DRAIN TANK INFORMATION FOR DEVELOPING DESIGN BASIS OF THE PRELIMINARY DESIGN

Prepared by
Tokamak Cooling Water System
US ITER

APPENDIX C.
QUESTIONS ASKED BY AREVA ON INFORMATION FOR THE DESIGN
BASIS OF THE DRAIN TANKS

Fig. 11. Temporary installation platform and route in the drain tank room.

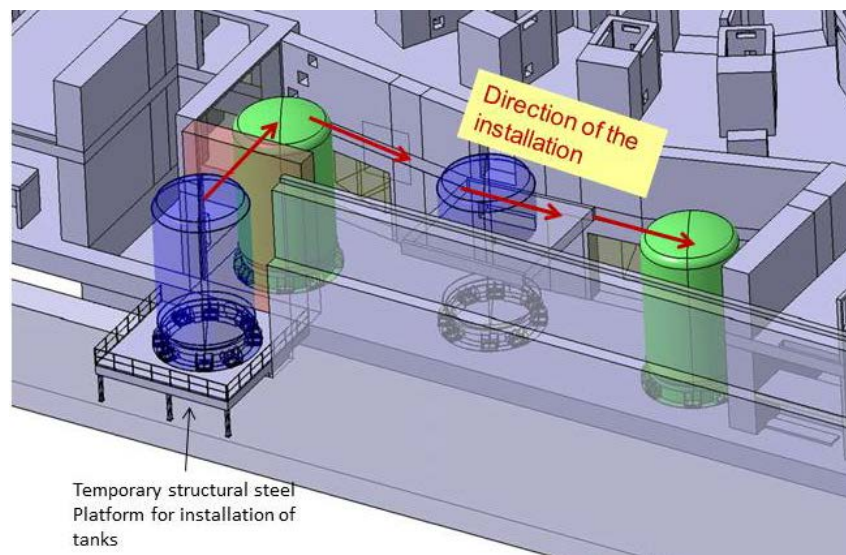
13	NBI connection to drying system—mistake on slide?	US ITER to review Figure 11 for services to tanks.		This will be fixed in the document by US ITER.
14	Minimum design metal temperature.	US ITER (Juan) to provide.		At B2 level (–11.6 m below the ground level), the minimum design temperature has been established at 12°C. US ITER will provide a list of environmental variables and their values at the same time this spreadsheet is delivered.
15	Electrical grounding for drain tanks.	How many grounding lugs will be required for each tank.	IO question.	It is not established yet. We need to uniform this according to the indications from the electrical section. I presume that could be at least two. However, there will be a workshop on TCWS I&C during October where this question will be definitively answered.
